RESIDENTIAL ENGINEERING SERVICES, LLC.
SHOP DRAWINGS/SUBMITTAL REVIEW

JOB No.	2704670
DESCRIPTION	SUMMIT HOMES
JOB ADDRESS	4416 SW ALABASTER CIRCLE
CITY	LEE'S SUMMIT, MO
DESIGNER	TODD W MOORE
DATE	3/8/2021

ROOF
TRUSS LAYOUT

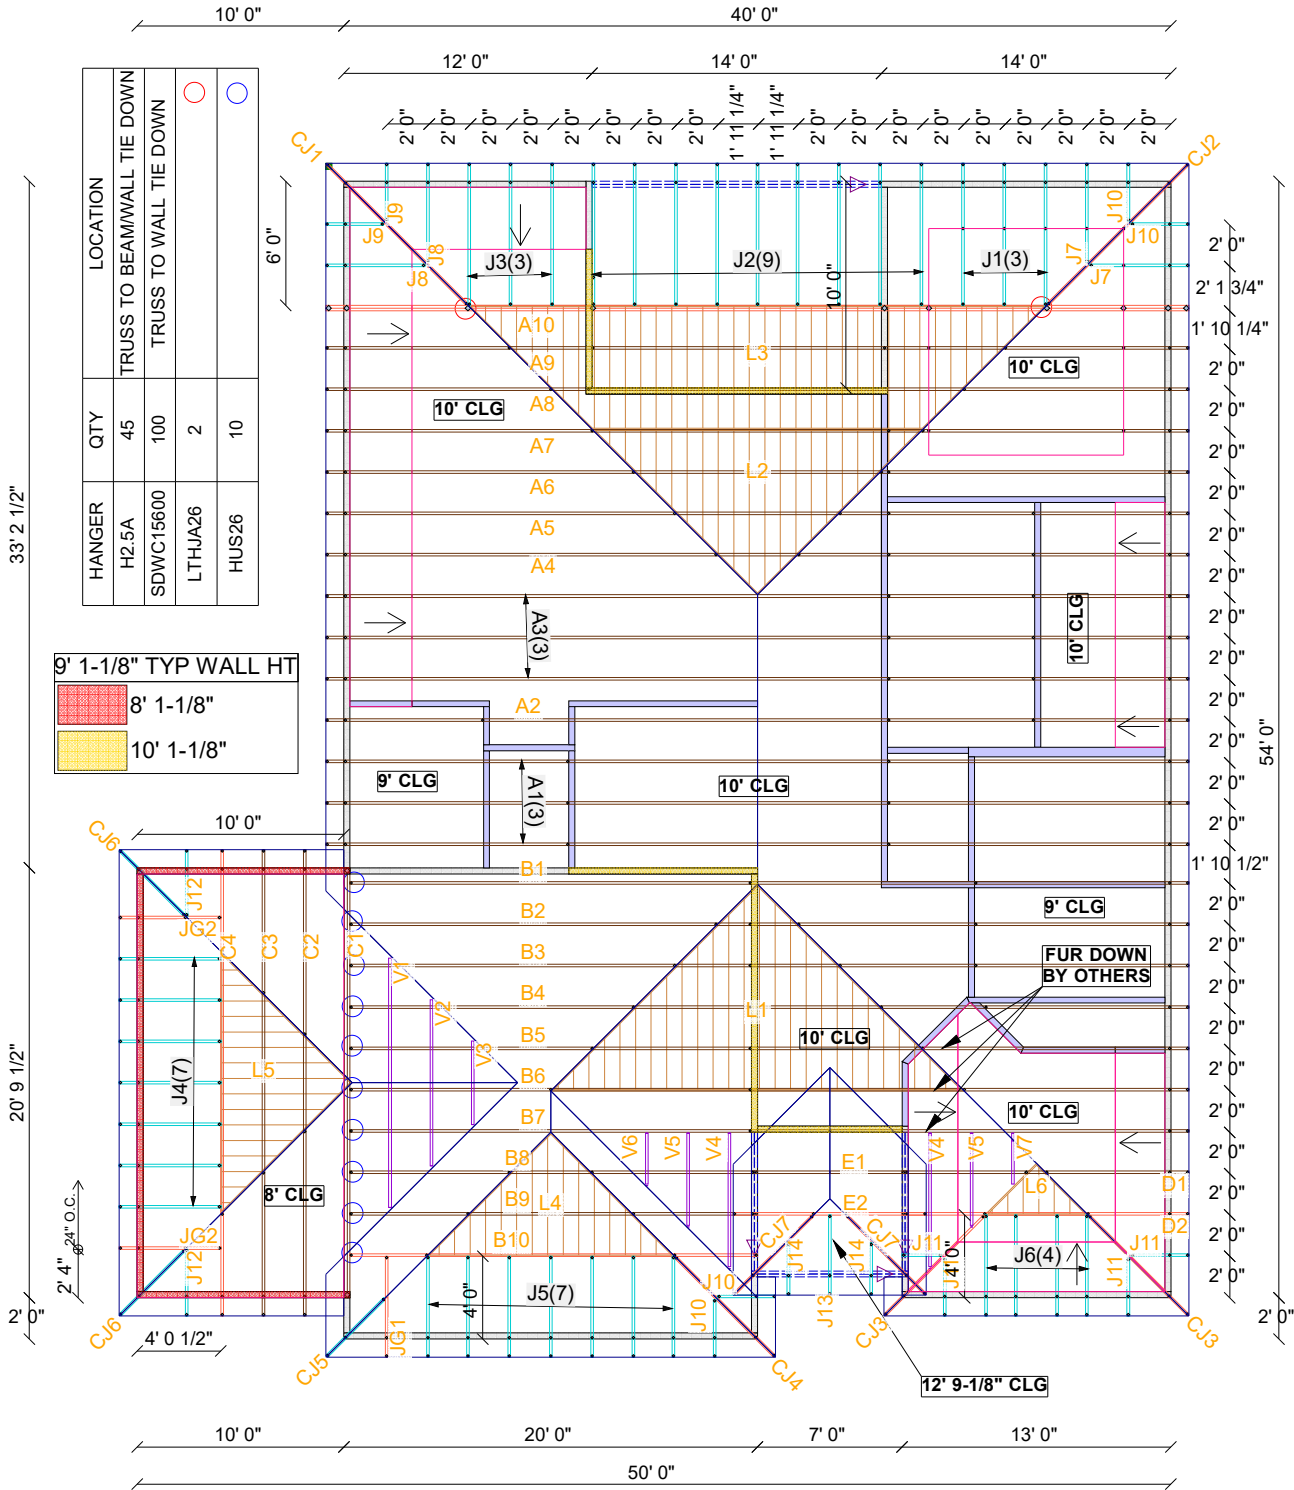
APPROVED
